Access Compliance Report

Public Rights-of-Way

(Curb Ramps)

Intersection ID: 19960	Main Street: ARCHDALE_DR	Cross Street: NETHERWOOD_DR	Location: NE
ADA ID: 6BAC808F562E	Ramp Type: PerpDiag	Initial Pass/Fail: Fail	Overall Compliance: No
Severity Score: 21.25			
Codes/Mitigation Info/Possible Solution		Field Measurements/Component Compliance

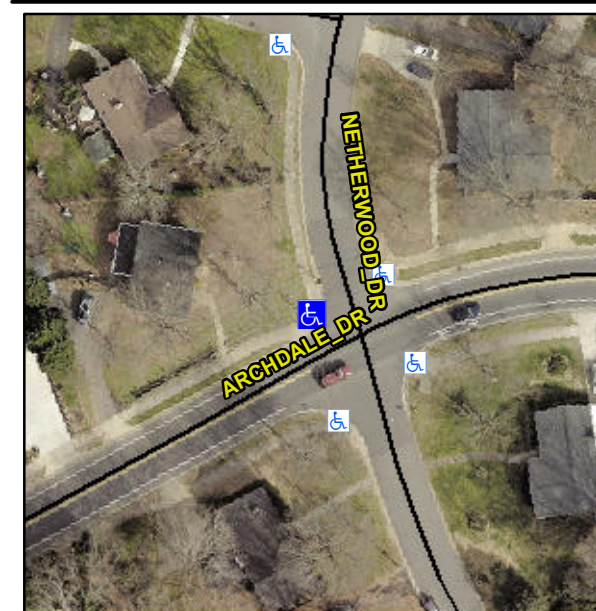
Not Found, R304.5.1, R304.5.3

Compliance	Description	Data	Compliance	Description	Data
N/A	Ramp Length (in)	71.0	Yes	Ramp Slope (%)	6.8
No	Ramp Width (in)	41.5	No	Ramp XSlope (%)	5.1
N/A	Flare Type LT	N/A	N/A	Flare Type RT	N/A
N/A	Flare Slope LT (%)	N/A	N/A	Flare Slope RT (%)	N/A
N/A	Flare Traversable LT?	N/A	N/A	Flare Traversable RT?	N/A
N/A	Landing Length (in)	N/A	N/A	DWS Provided?	N/A
N/A	Landing Width (in)	N/A	N/A	DWS Contrast?	N/A
N/A	Landing Slope (%)	N/A	N/A	DWS Length (in)	N/A
N/A	Landing X Slope (%)	N/A	N/A	DWS Full Width?	N/A
N/A	Landing Curb? (Y/N)	N/A	N/A	DWS Offset (in)	N/A
N/A	Shared Landing?	N/A			
N/A	Gutter Ponding?	N/A	N/A	Gutter Slope (%)	N/A
N/A	Gutter Lip Ht (in)	N/A	N/A	Gutter X Slope (%)	N/A
N/A	Painted X Walk1?	No	N/A	Painted X Walk2?	No
	X Walk 1 Direction	To S		X Walk 2 Direction	To NW
N/A	X Walk 1 Width (in)	N/A	N/A	X Walk 2 Width (in)	N/A
	X Walk 1 Slope (%)	2.6		X Walk 2 Slope (%)	7.6
	X Walk 1 X Slope (%)	8.7		X Walk 2 X Slope (%)	2.1

Remove & Replace Curb Ramp With Two New Directional Ramps or Equivalent.
